Service Bulletin

Bulletin No.: 16-NA-014

Subject: Delayed Engagement After Sitting With Engine Off

4358775

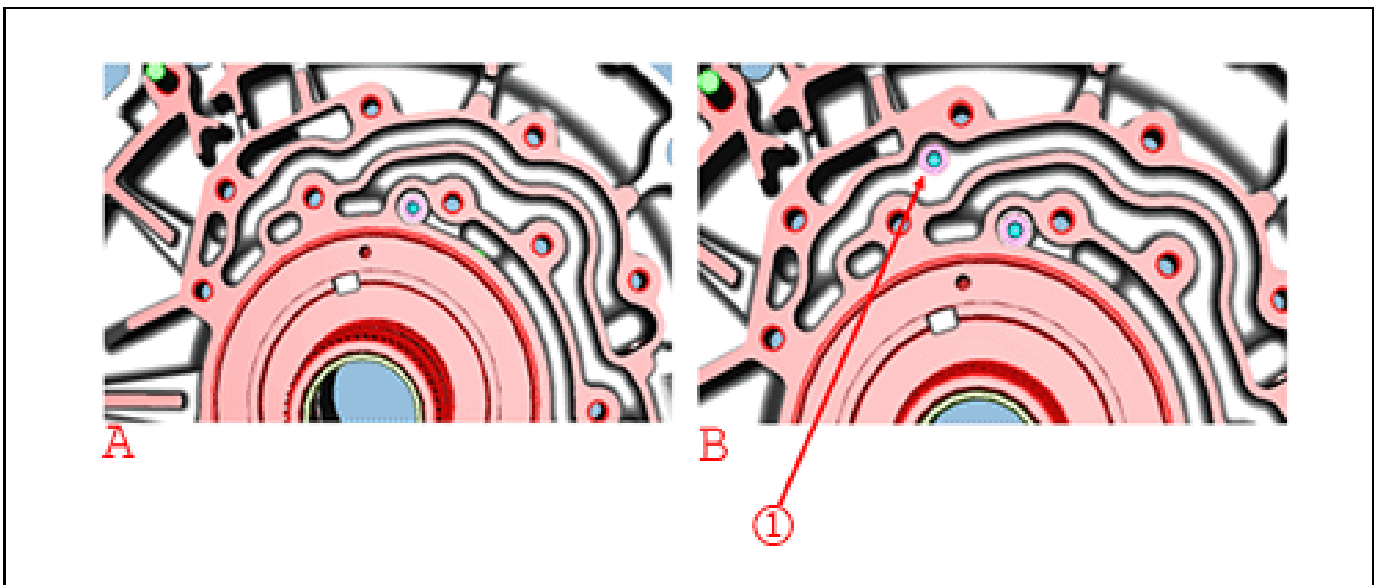
Note: The new stator shaft support assembly has a second check ball (1) added (see illustrations).

Install a new stator shaft support assembly that includes an additional check ball. Follow the instructions below to replace the stator shaft support assembly.

4358782

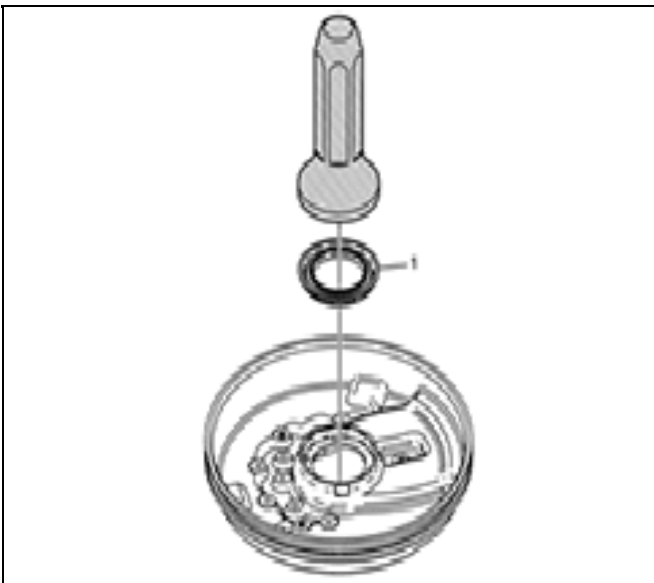
Note: The casting void has been eliminated from the underside of the cover (see illustration).
